# SOLACE APARTMENTS FILING NO. 1

## CONSTRUCTION DOCUMENTS

EPC STORMWATER REVIEW COMMENTS  
IN ORANGE BOXES WITH BLACK TEXT

RECORD DRAWINGS  
06/23

**FOREBAY A1 PLAN VIEW**  
SCALE: 1" = 2'

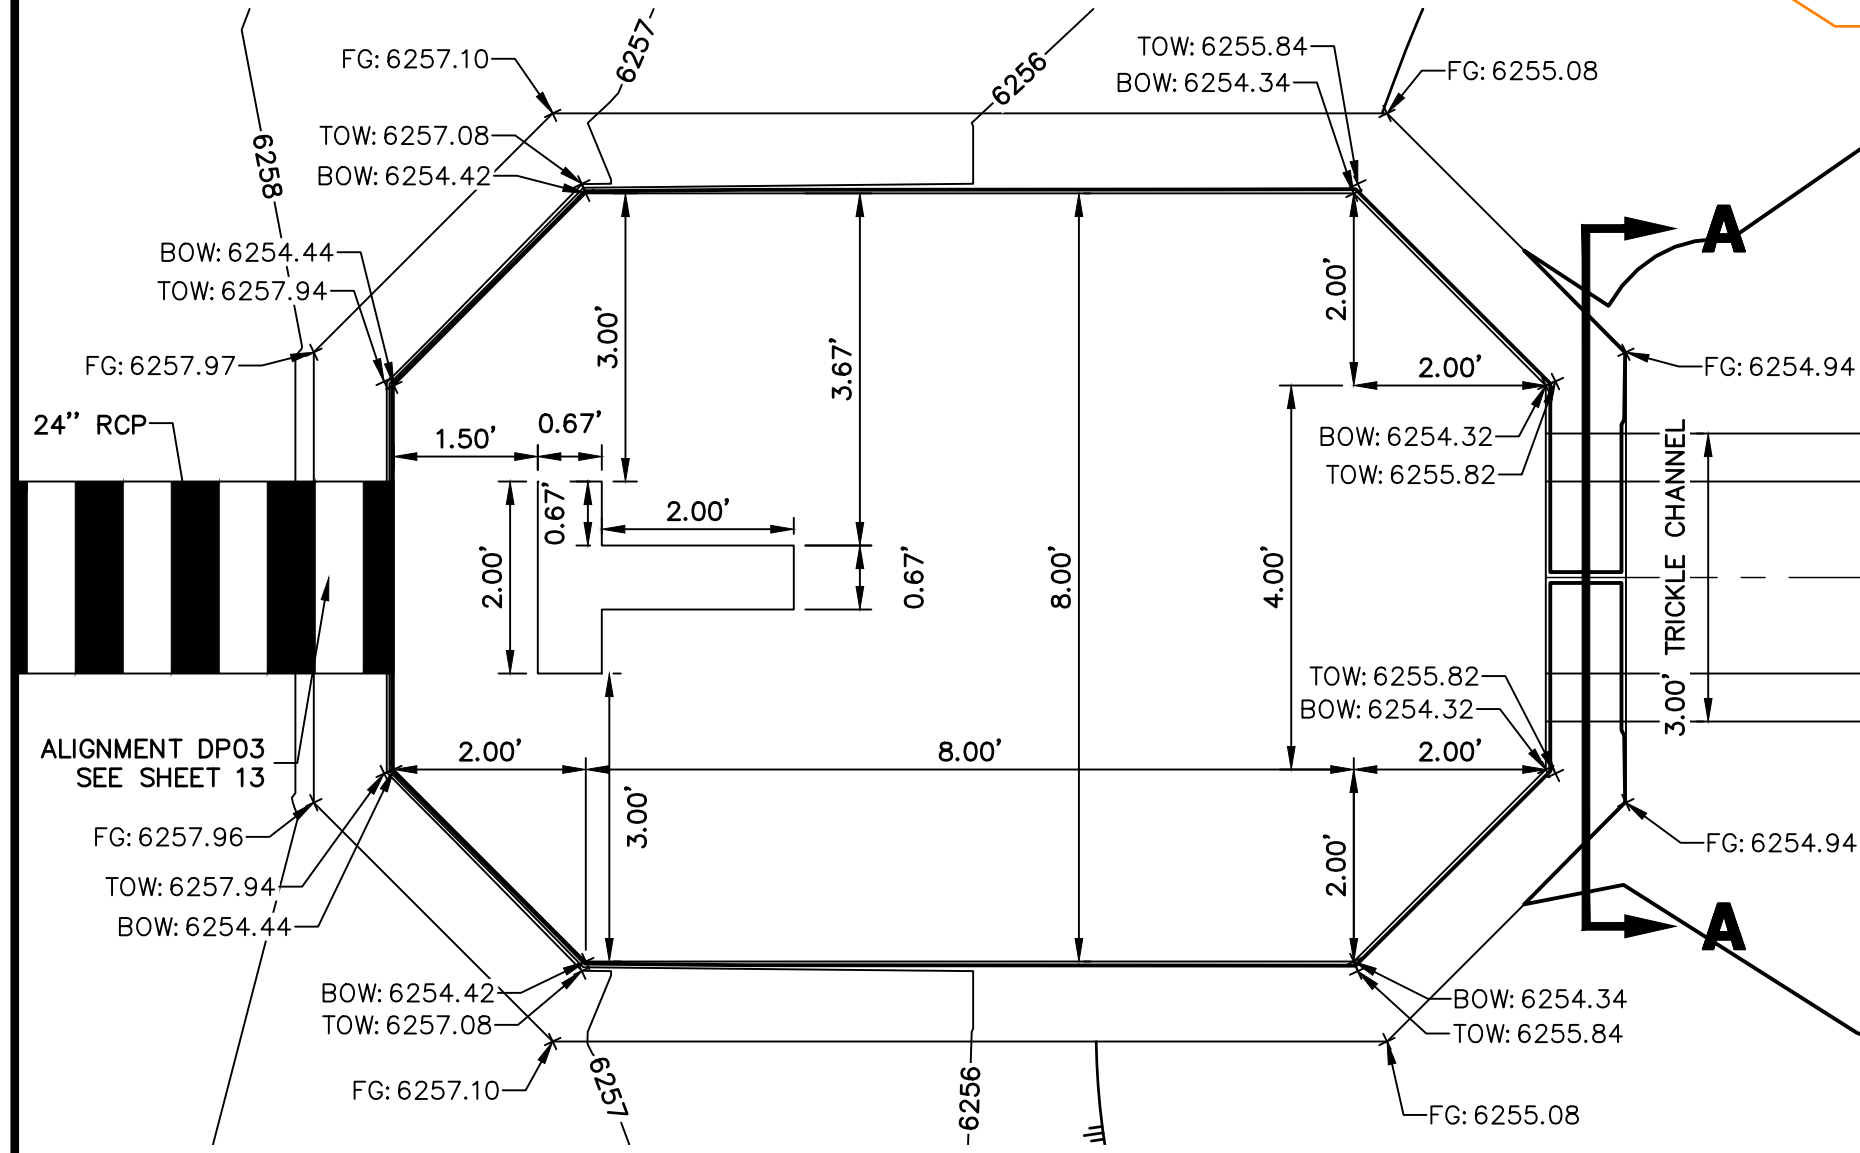
The constructed forebay notches are 3.5" wide and rectangular. Show this change on as-builts and provide calculations to demonstrate the design is still sufficient.

Due to the pipe extending past the headwall, the distance between pipe end and baffle is shorter. Show on as-builts

**FOREBAY B1 PLAN VIEW**  
SCALE: 1" = 2'

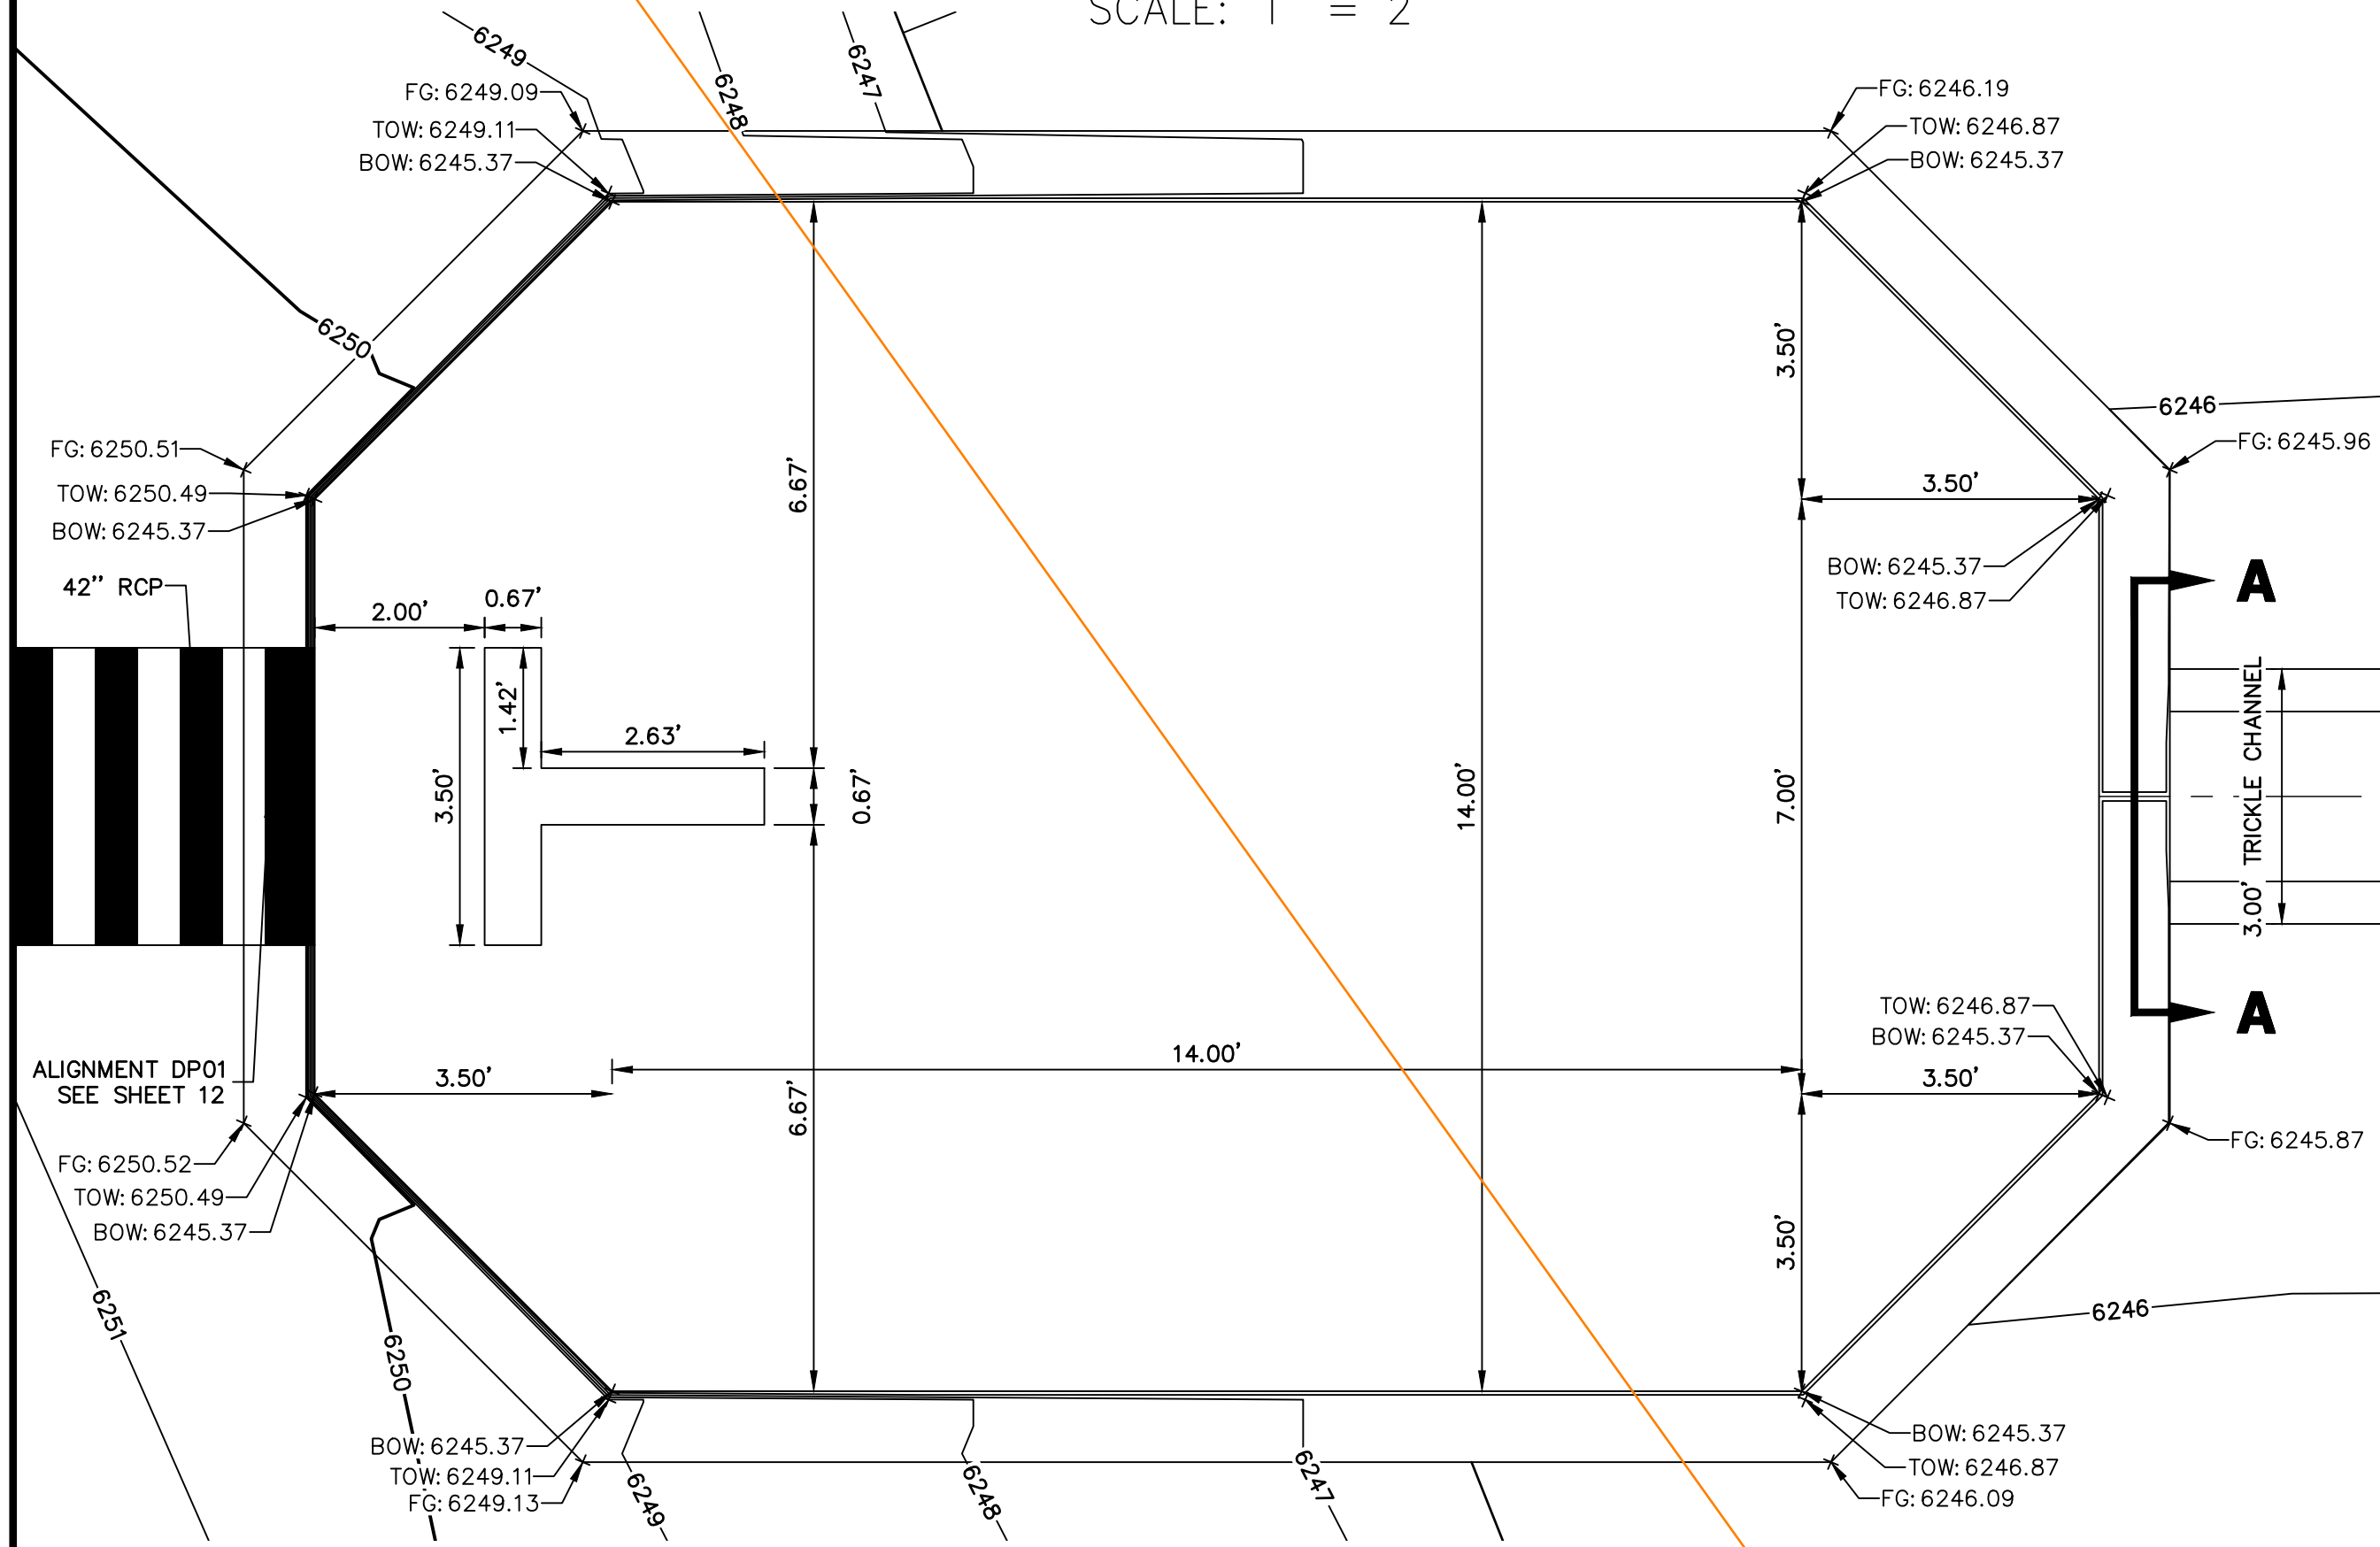
The constructed forebay notches are 3.5' wide and rectangular. Show this change on as-builts and provide calculations to demonstrate the design is still sufficient.
